Promemoria (PM)

DokumentID 1372883	Version 1.0	Status Godkänt	Reg nr	Sida 1 (52)
Författare Jan-Olof Selroos			Datum 2012-12-10	
Kvalitetssäkrad av Allan Hedin			Kvalitetssäkrad datum 2012-12-20	
Godkänd av Helene Åhsberg			Godkänd datum 2012-12-21

Reply to questions by SSM

In this PM, answers are provided to questions raised by Georg Lindgren, SSM in a request for clarifications (dated 2012-05-29 with SSM's reference number SSM2011-2426).

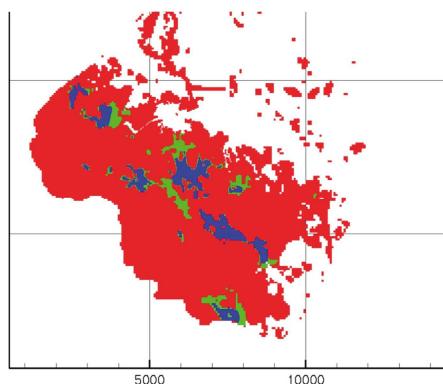
Under första punkten hänvisas till tabell 4-1. Finns det en referens till var värdena i tabellen kommer ifrån?

SKB:s svar 2011-12-07: The properties for the top 20 metres are found from the calibration of the ground water level for undisturbed conditions. The relation to field data is given by Figure 4-5.

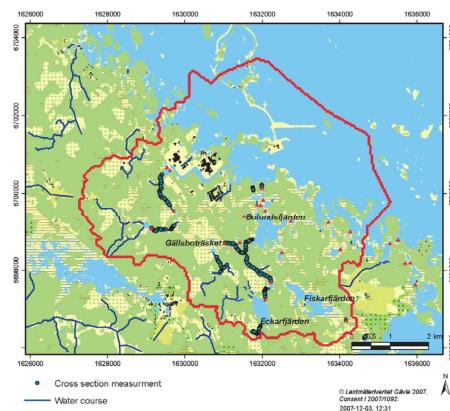
- Var finns kalibreringen av grundvattennivåerna redovisade?
- Vilka data baseras figur 4-5 sida 40 på och var finns det redovisat?

a) Calibration

p. 60 in Svensson and Follin (2010; R-09-19):
Figure 5-2. Areas with a predicted groundwater table (hydraulic head) above ground surface are marked blue, whereas areas with a predicted groundwater table below, but very close, ground surface are marked green. The latter may be perceived as wetlands, cf Figure 4-7. In the red areas the groundwater table is significantly below the ground surface.

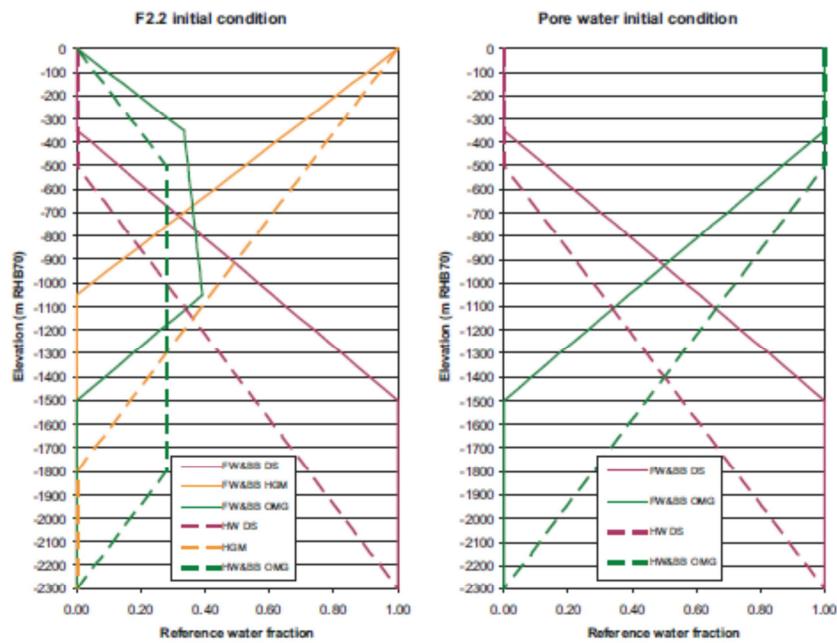
Det verkar inte framgå ur SKB R-08-23 hur de initiala trycken har definierats. Hur är förhållandet mellan salinitet och tryck som tillämpas i modelleringen? Observera att samma fråga ovan relaterar till DarcyTools modelleringen.

The initial conditions for the salinity are defined on p 51 in Follin et al. (2008; R-08-23):

The hydrostatic pressure is, as always, defined as:

$p(z) = -g \int \rho(z) dz$, where the integral runs between the elevation of interest ($=z$) and the elevation of the water table. Thus, if the salinity increases linearly with depth, the pressure increase is quadratic.

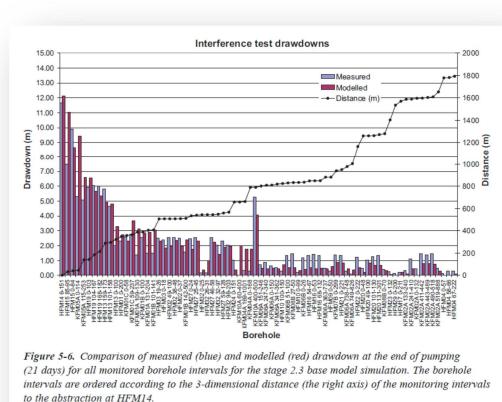
Finns det några resultat som visar en jämförelse mellan uppmätta tryckdata (eller motsvarande) och modellerade tryck annat än för de förhållandevis små djup som visas i ECPM kalibreringen mot grundvattendjup och tryck i det ytliga berget?

The sparse fracturing at depth inside the target volume together with a general depth trend of decreasing transmissivity make it difficult to find sufficiently transmissive sections that show anything but tidal and barometric responses. The greatest head responses are observed during the interference tests and these are documented and analyzed in the report, e.g. Figure 4.9 and Figure 5.6 in Follin et al. (2008; R-08-23). In the latter figure, measured and modelled responses are shown for 74 monitoring sections. Fifteen of these represent groundwater levels that are measured in deep monitoring sections i.e. that have the lowermost packer below 300 m borehole length:

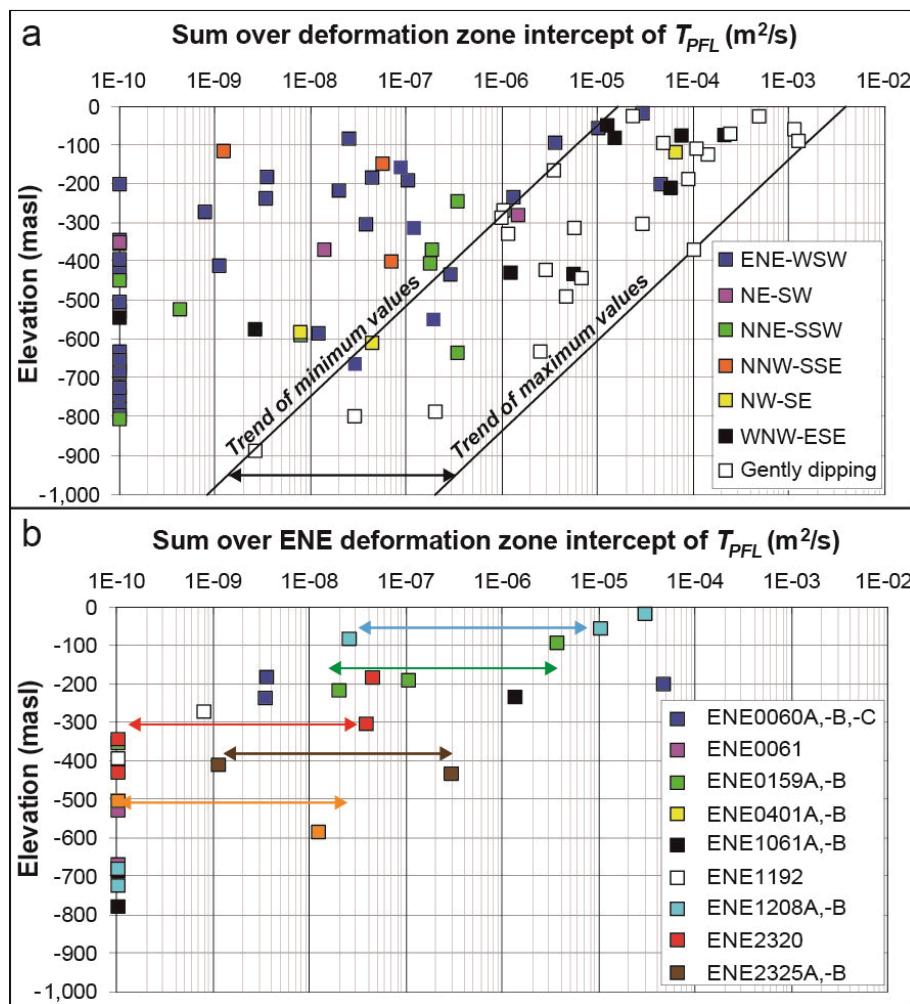
R-09-22 sida 24 ekvation (2-1): det antas ett djupavtagande av transmissiviteten för branta deformationszoner. Detta parametriseras baserat på data från flacka zoner (R-07-48 sida 122). Till synes finns ingen uppenbar djuptrend för branta zoner (se exempelvis figur 2-4 R-09-20 sida 17 där exempelvis NNW-zondata visar ökande transmissivitet med djupet). Vad är argumentet för att parametrisera ett djupavtagande av transmissiviteten för alla branta zoner?

Figure b below is a replicate of Figure 9-4 in Follin et al. (2007; R-07-28). This plot shows values of T for the ENE steeply dipping deformation zones, which is the most frequent steeply dipping deformation zone set. The lateral spread at each elevation is approximately equal to the lateral spread of the gently dipping zones shown in Figure a which is a replicate of Figure 9-1 in Follin et al. (2007; R-07-48).

The three data that represent NNW-SSE zones in Figure a represent two different zones, where the two leftmost values come from the same zone. Indeed, these data reveal that there is a lateral heterogeneity also for the NNW-SSE zones and that each zone has its own T(0) value. Thus, the postulated deterministic depth trend model for the mean is not necessarily falsified.

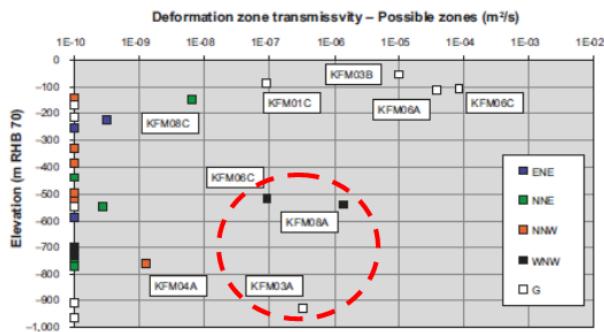
SKB R-09-22 figur 2-6 sida 20: Figurtexten hänvisar till SKB R-08-23 där samma figur (4-2) finns på sida 67. Enligt figurtexten är figur 4-2 en reproduktion av figur 3-14 på sida 29. Vid närmare betraktelse visar sig figurerna inte vara lika. I figur 3-14 finns exempelvis en så kallad "possible deformation zone" med som inte finns i figur 3-14 (en WNW zon på ca 550 m djup med drygt 1e-6 m²/s transmissivitet). Enligt figurtexten till figur 3-14 är denna reproducerad från SKB R-07-48. I R-07-48 finns motsvarande figur (9-1) på sida 116. Figuren hänvisar till tabell 9-1. Det kan noteras att vissa punkter i figuren inte finns med i tabellen och tvärt om.

- a) *SSM önskar att SKB klargör ovanstående oklarheter.*
- b) *Används värden i appendix L i R-07-49 även för fallet utan lateral variabilitet i HCD i SR-Site?*
- c) *Finns de deterministiskt modellerade zonerna som ingår i SR-Site basmodellen och deras egenskaper sammanhållet redovisade?*

Figure 3-14 in Follin et al. (2008; R-08-23) requires some explanations however. The version pasted in Figure 3-14 differs from the correct version discussed above in that three data values representing borehole intervals with deformation zone type properties are included; see the figure shown below which is a replicate of Figure 7-2 in Follin et al (2007; R-07-48).

The statement on p 20 in Follin et al (2008; R-08-23) that all of the 28 minor deformation zones are included in the local model domain is almost correct. There is at least one MDZ that is entirely outside the local model domain, see Figure 3-9 in Follin et al. (2007; R-07-49). This zone is known as Zone 6 in the hydrogeological model for the bedrock at the Forsmark-SFR site.
